CORRESPONDENCE

Journal : **Indonesian Journal of Geography**

Title : River Flow Modelling for Sustainable Operation Of Hydroelectric Power Plant in the Taludaa-Gorontalo Watershed

Author : **Sardi Salim**¹, Muchlis Polin²

Figure 1. Curve of water level versus discharge

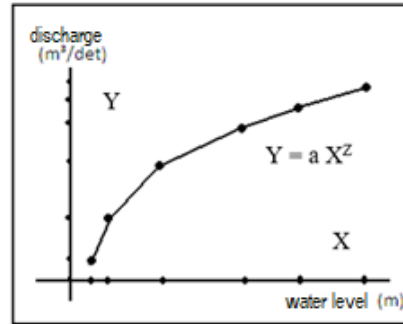
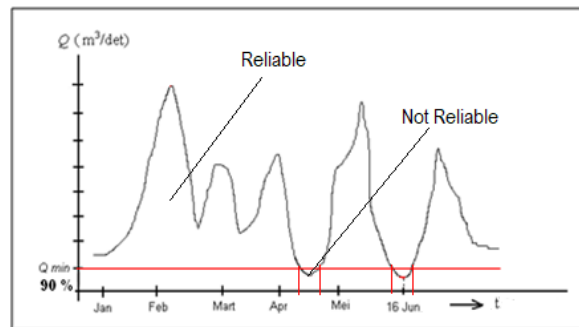
Figure 1 and 2 has no scale such as 1,2,3, etc.

Figure 4. Map of the Taludaa–Gorontalo watershed

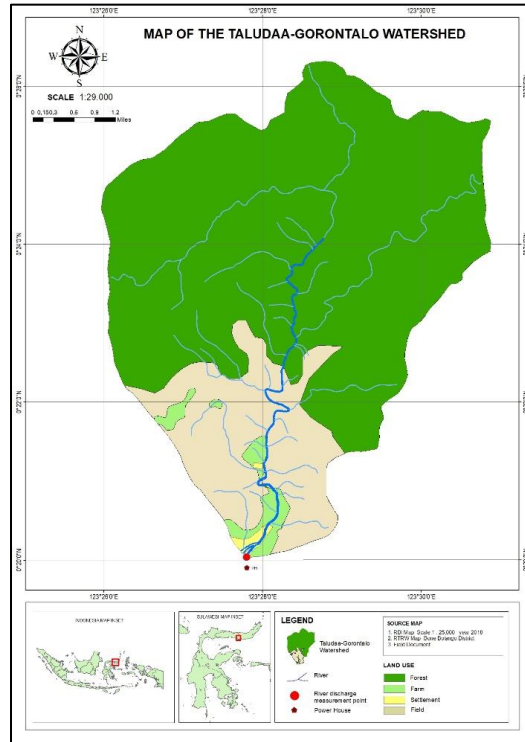
8. Are all figures, tables, and photos necessary, appropriate and well designed? YES/NO	(Please make sure, if the figure is a map: a country map (as an inset) is required for all studies, locating the study area. On every map, include a metric scale bar and a north arrow, and latitude-longitude)	8. Yes, all of the table are oke. But, Figure 1 and 2 has no scale such as 1,2,3, etc. The map (Fifure4) should follow the standard of the map. Blue colour usually used figures the water. However in this research the blue colour is the watershed area.

Thank you. I have fixed the map and added an inset of Indonesia as well as put an indicator of the research location.

6	The text is clear and interesting, however it discuss more about watershed characteristics and then ended with the electric power before the conclusion	The research discussion has explained the stages of modeling rainfall into runoff (discharge) which is influenced by the parameters of the watershed system. discharge is one of the components to obtain electrical energy in the river flow
7	revised some of the typo: modeling→ modelling. Some sentences were written in passive form, please make active sentences to be more appropriate in English writing style	thank you, modeling has been changed to modeling and some words have been corrected. the sentence has been adjusted to become an active sentence
8	Yes, all of the table are oke. But, Figure 1 and 2 has no scale such as 1,2,3, etc. The map (Fifure4) should follow the standard of the map. Blue colour usually used figures the water. However in this research the blue colour is the watershed area.	Thank you, The map has been replaced according to the correction provided.
